Re: Initial Submission Review – Revolve Denali at Windler – Site Plan
Application Number: **DA-1707-25**
Case Numbers: **2023-4003-00**

Second Submission Review

Revolve Denali at Windler – Site Plan

DEN Aviation Noise:

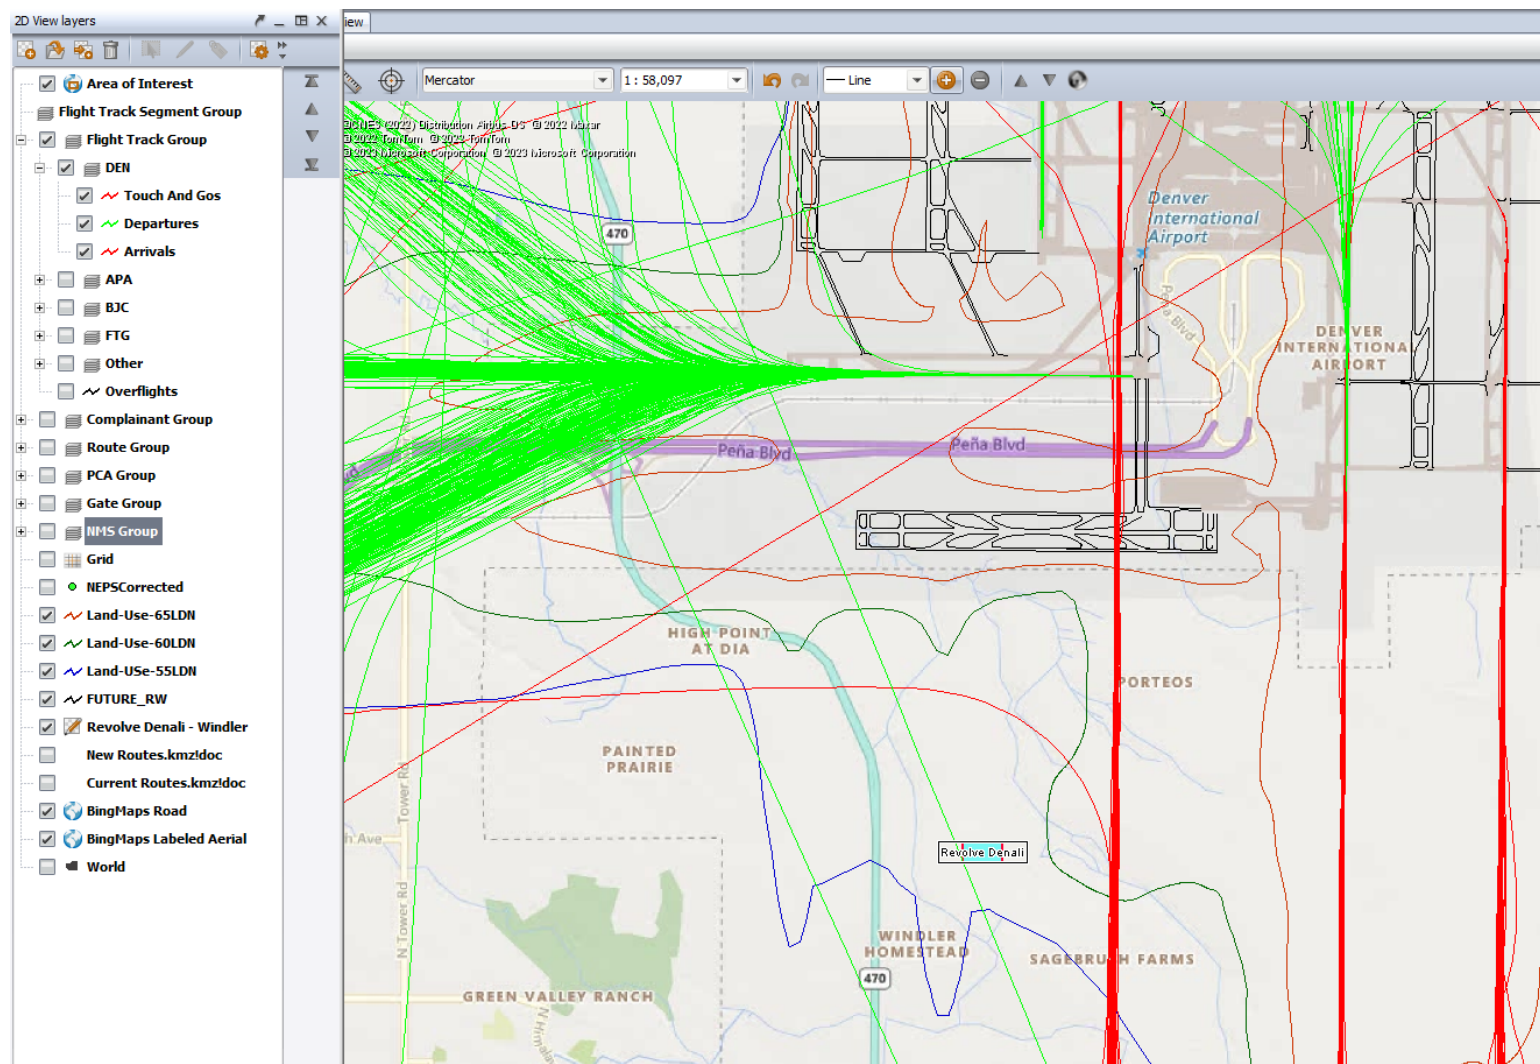
This property will be subject to overflights to and from Denver International Airport (DEN). Included are flight track maps showing the different flight track pattern scenarios and their altitudes related to the arrivals and departures at DEN. All related aviation noise statements should be included in any information sharing, documentation and contracts.

This subject property area is not currently under and arrival pattern, the future north/south runways on the west side of the airfield will put arrivals over the subject property. This portion of the development could potentially have arrival overflights from the south at altitudes of between 1,100 feet above ground level (AGL) and 1,500 feet AGL depending on the aircraft type and what arrival runway the Federal Aviation Administration (FAA) air traffic controllers have directed the aircraft to land on. If the winds are out of the north aircraft will land coming in from the south on final approach to DEN. Aircraft currently arrive to DEN on runways 34L and 34R and with the potential of 4 North/South runways on the West side of the airfield there could be even more daily arrival overflights of this development. The future runways are depicted in black on this map of flight data from 3/7/23. This days of flights depicts a typical flight pattern for a 24 period. See next page for a zoomed in version.

DEN Aviation Noise:

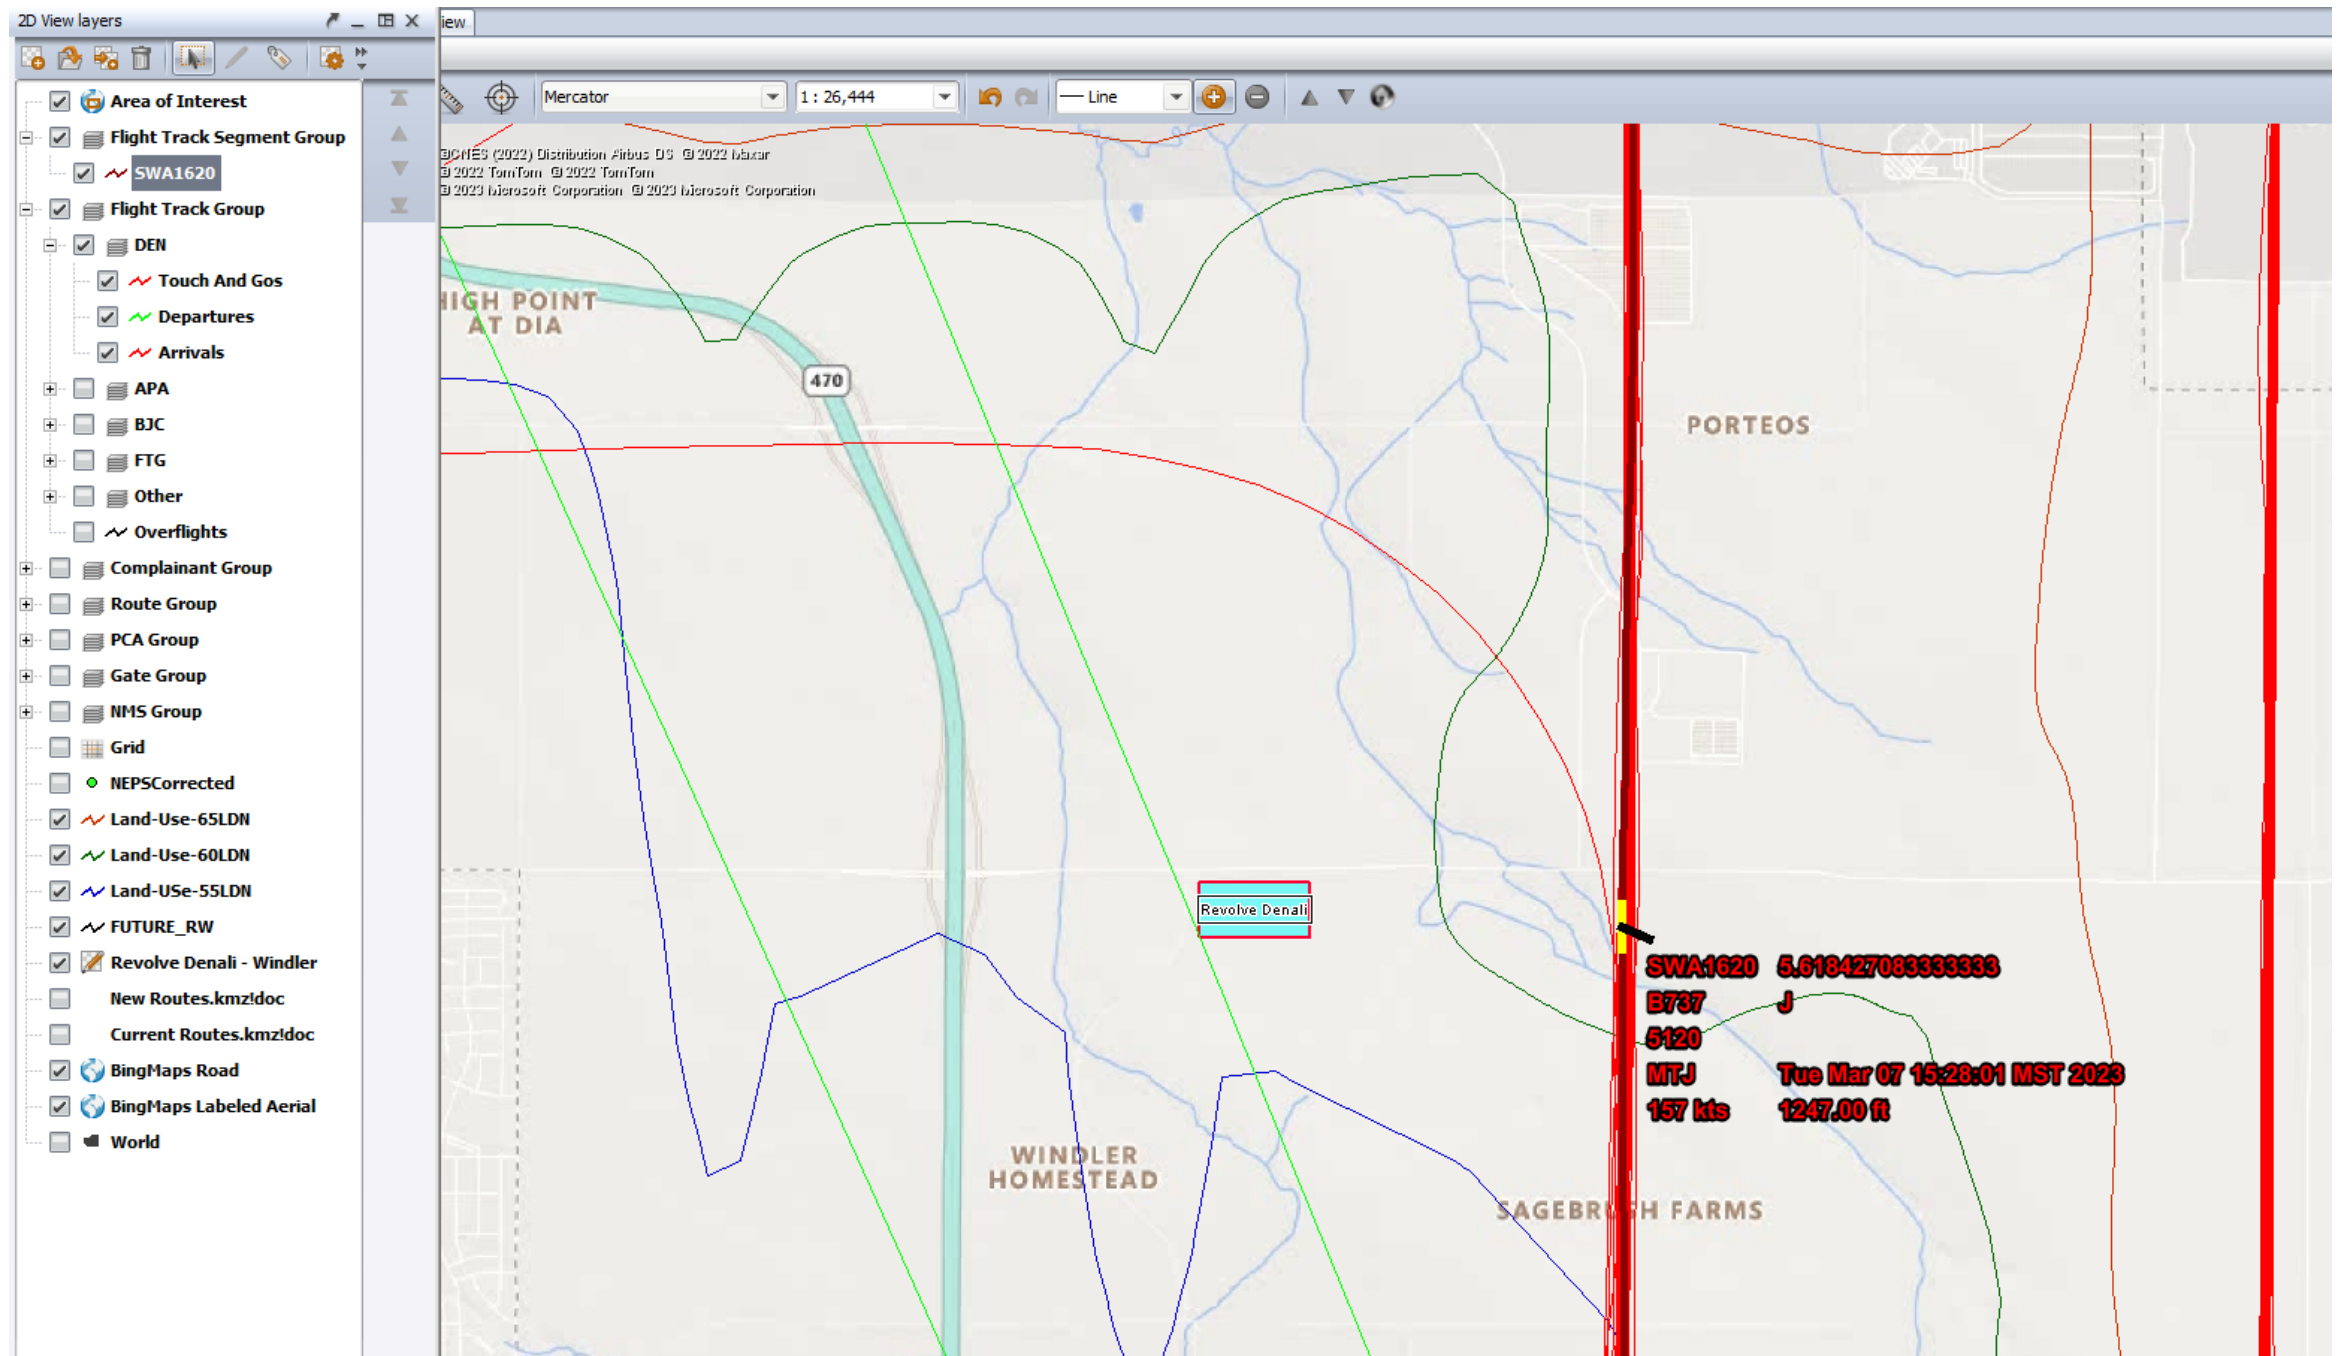
Same flight data from 3/7/23, zoomed in to see the 55, 60 and 65 DNL contour and the property area in light blue. This subject property lies within the 55 DNL. This portion of the 55 DNL contour shows the noise footprint of aircraft arriving/departing to/from the additional 2 potential north/south runways on the west side of the airfield. Once the runway straight north-northwest of this property is built, 16C/34C (might be the runway name) there will be overflights at the beforementioned altitudes. There could be upwards of 200+ arrivals per day to those current/future runways, at anywhere between 1,110 feet AGL to 1,500 feet AGL depending on the aircraft type.
